# DeKalb County Historic Preservation Commission

Monday, August 17, 2026- 6:00 P.M.

## *Staff Report*

F. 1380 Emory Road, Jennifer Witherspoon. Constructing a new garage with an accessory dwelling unit and repairing the landscaping in the back yard. **1248208.**

A.2

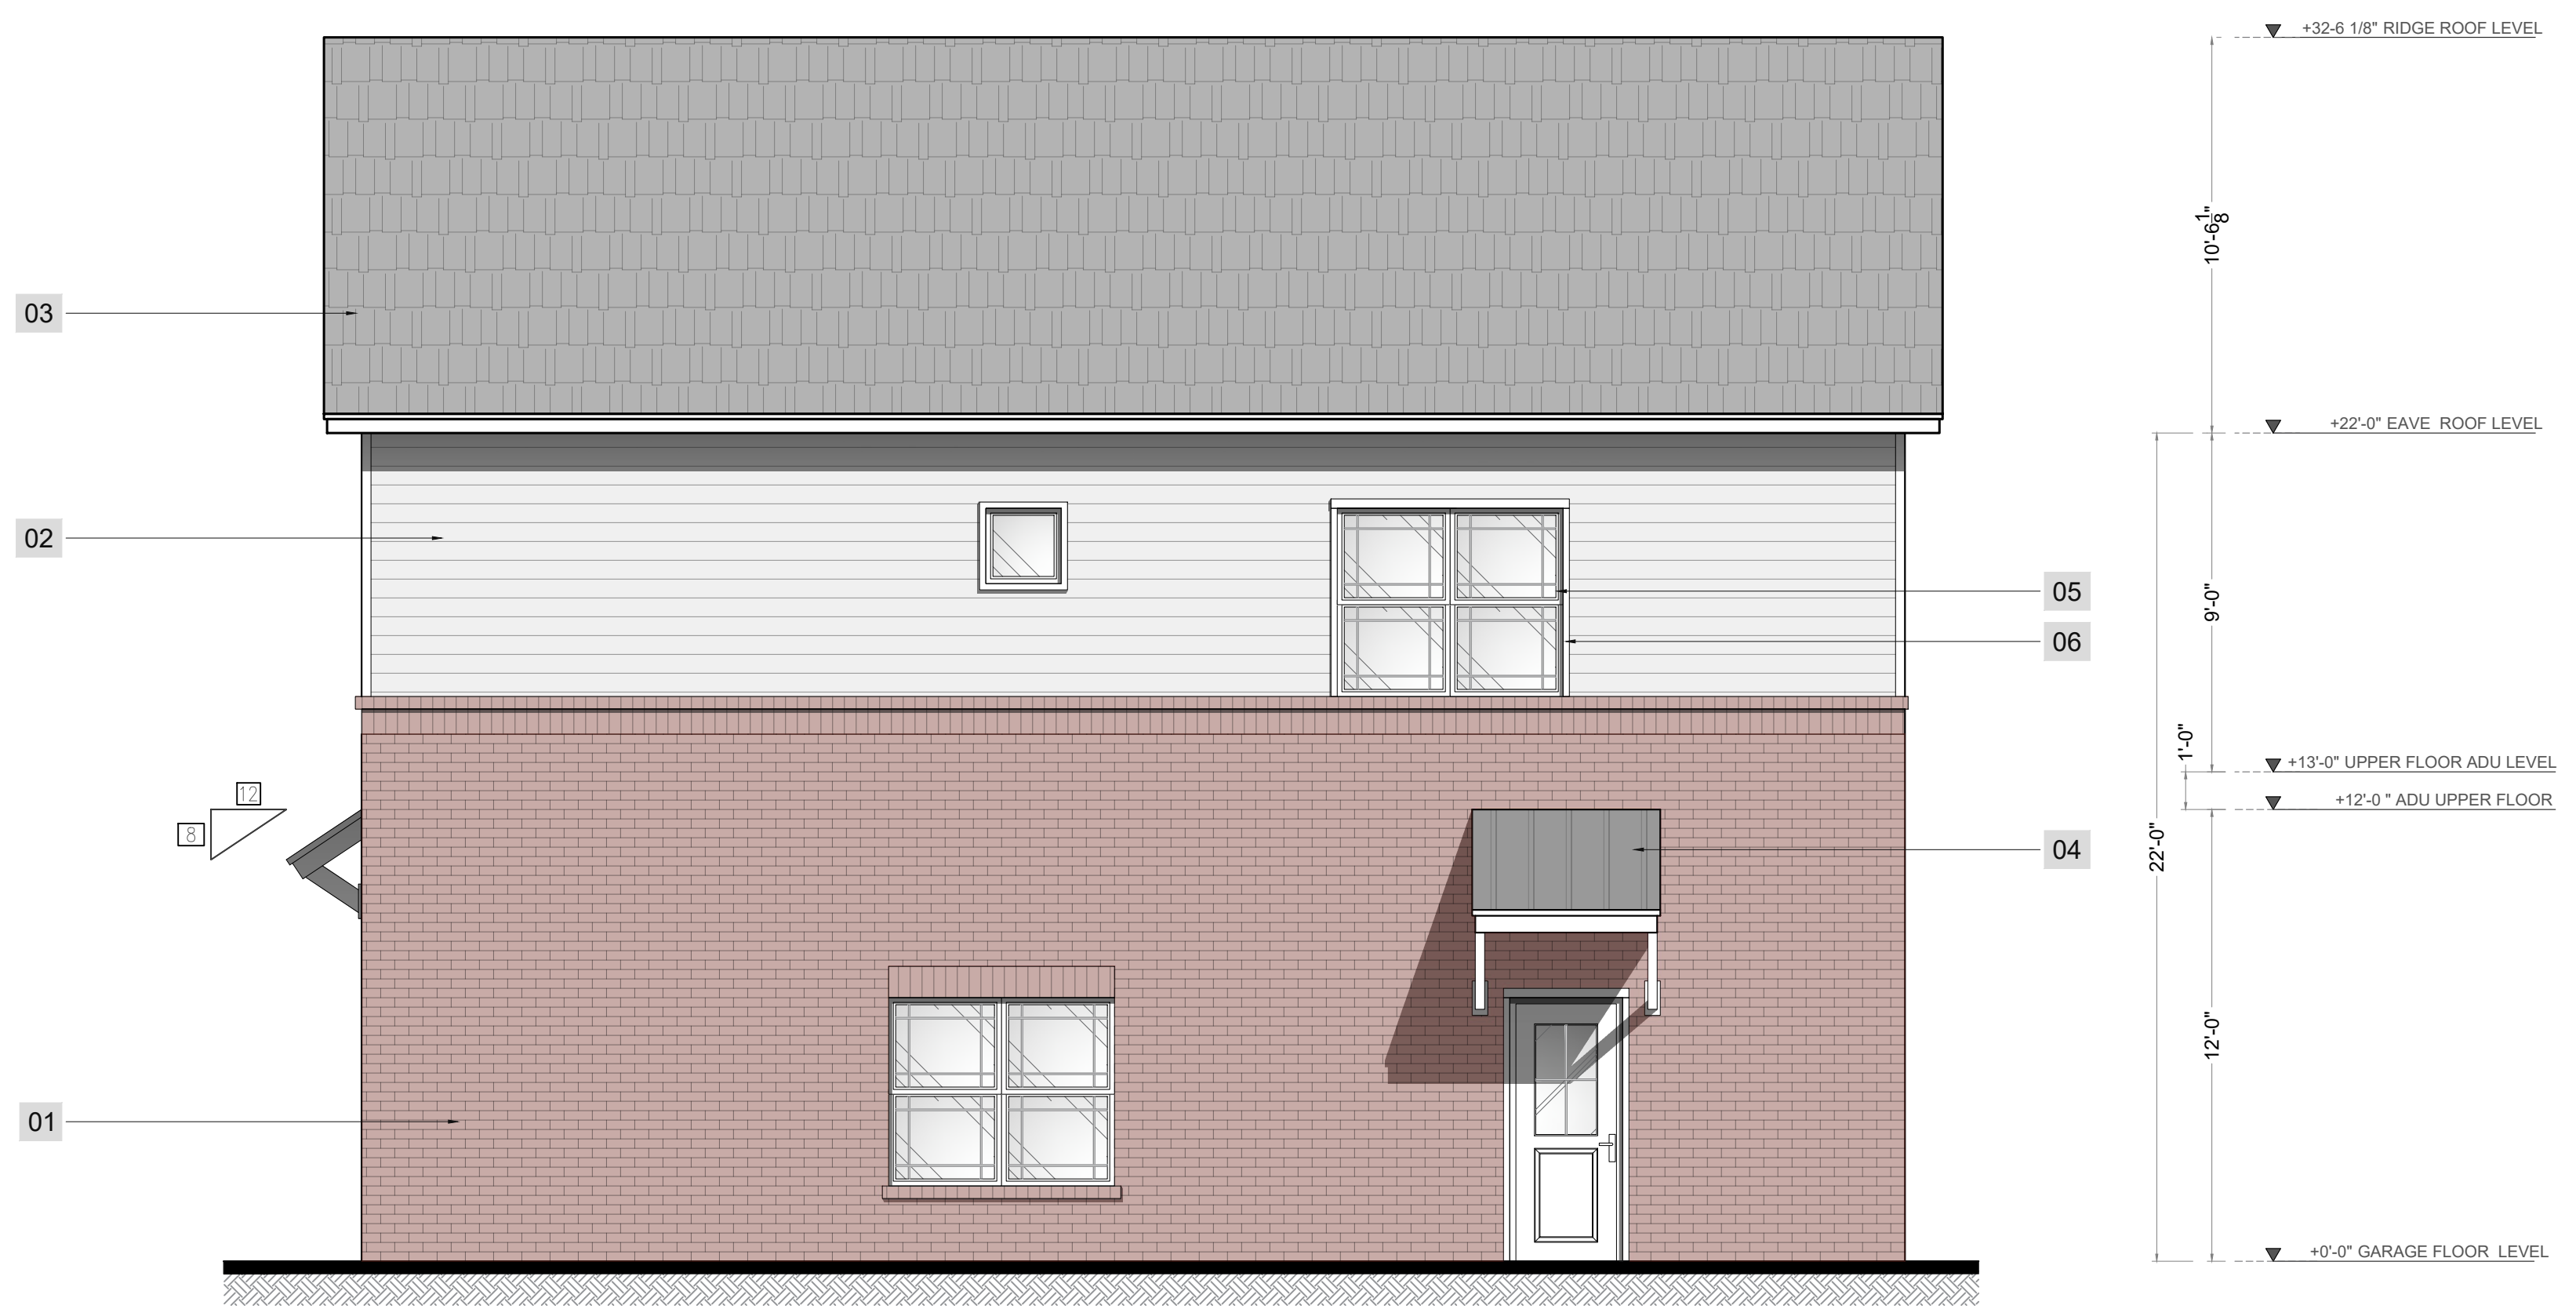
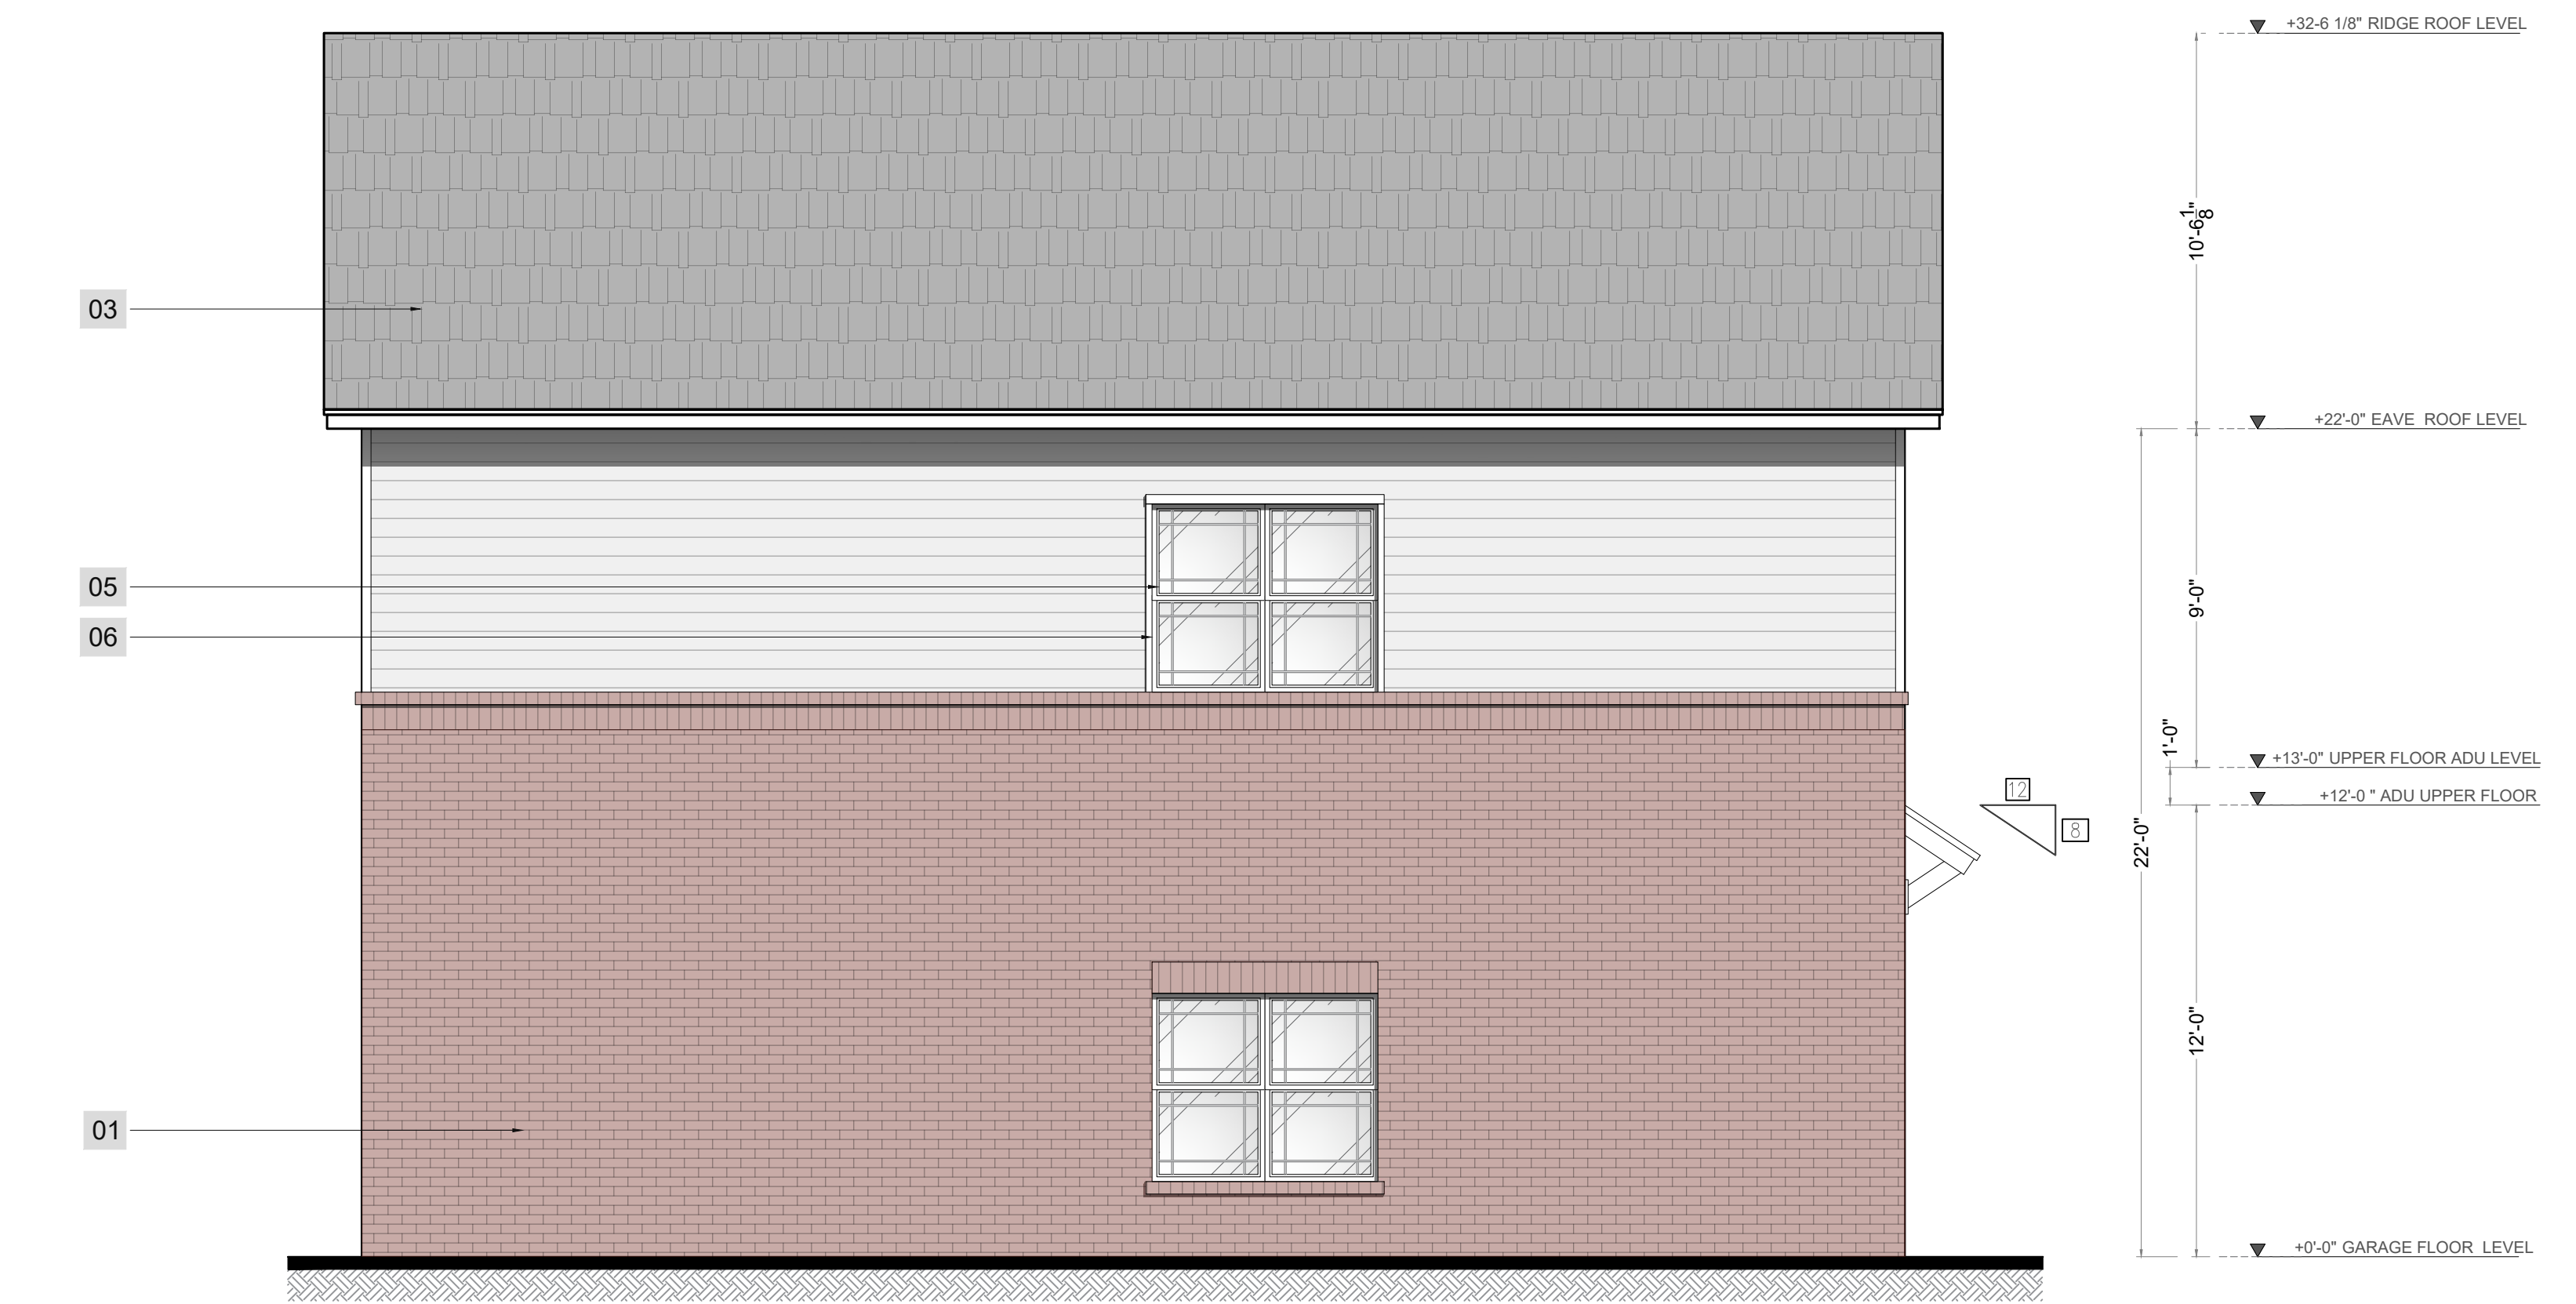
The application was deferred to the next scheduled meeting in order for the applicant to coordinate with staff regarding a mitigation plan for the existing non-complying AC unit<sup>4</sup> and provide plans for review to the Commission. Additionally, more information regarding the proposed accessory structure was requested by Commission members in order to understand the scale of the structure in comparison to the historic house on the property.

Due to proposed height of the accessory structure on the property, a variance will need to be acquired from the Zoning Board of Appeals before a building permit can be issued, as the structure

appears to exceed height requirements for accessory structures on single family detached dwelling properties<sup>5</sup>.

**Approved with Modification.** Staff recommends that the proposed accessory structure and landscaping of the rear yard be approved with the requirement that the existing external AC unit recorded by Code Compliance be removed or that vegetation be installed to mitigate the appearance of the unit from the Right of Way in accordance with Guideline 6.2. The installed vegetation should include plantings from the recommended vegetation list found in Guideline 9.3 of the Druid Hills Design Manual.
